35/92-02A 3712 Thornapple St. (MP #35/92) Moxley-Taplin House

Re: Fence design

Historic Area Work Permit #275084

HISTORIC PRESERVATION COMMISSION STAFF REPORT

GARDEN FENCE / GATE ELEVATION - N.T.S.

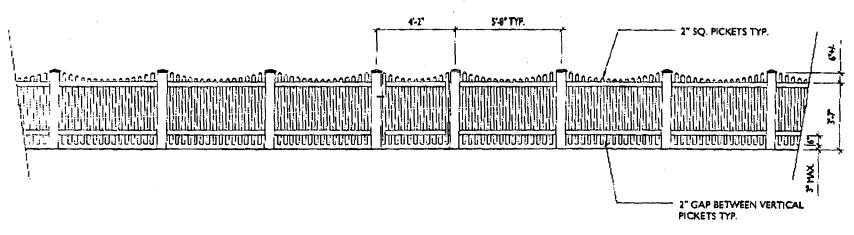
We have received the letter from Steve Daigler of Jordan Honeyman regarding your fence. This letter has been reviewed by staff and the fence design has been approved. The original condition of your historic Area Work Permit stated that the fence must be painted, so I want to reiterate that requirement as it wasn't mentioned in the letter or on the drawings. No additional Historic Area Work Permit is required for this fence installation.

Here are the drawings we discussed over the phone. The first is a location drawing showing the locations of new sections of fence to be erected as replacements for fences existing in the same locations. The other two are elevations of the proposed fence designs. The drawing identified as "Property Line/Pool Fence/Gate Elevation" shows the elevation from the pool side of the fence; the other side, as per Montgomery County Zoning regulations for pool fencing, would have no horizontal rails. (The swimming pool is in the neighbor's yard, and not shown on the location drawing.) The "Garden Fence/Gate Elevation" drawing shows the fence as it would look from both sides.
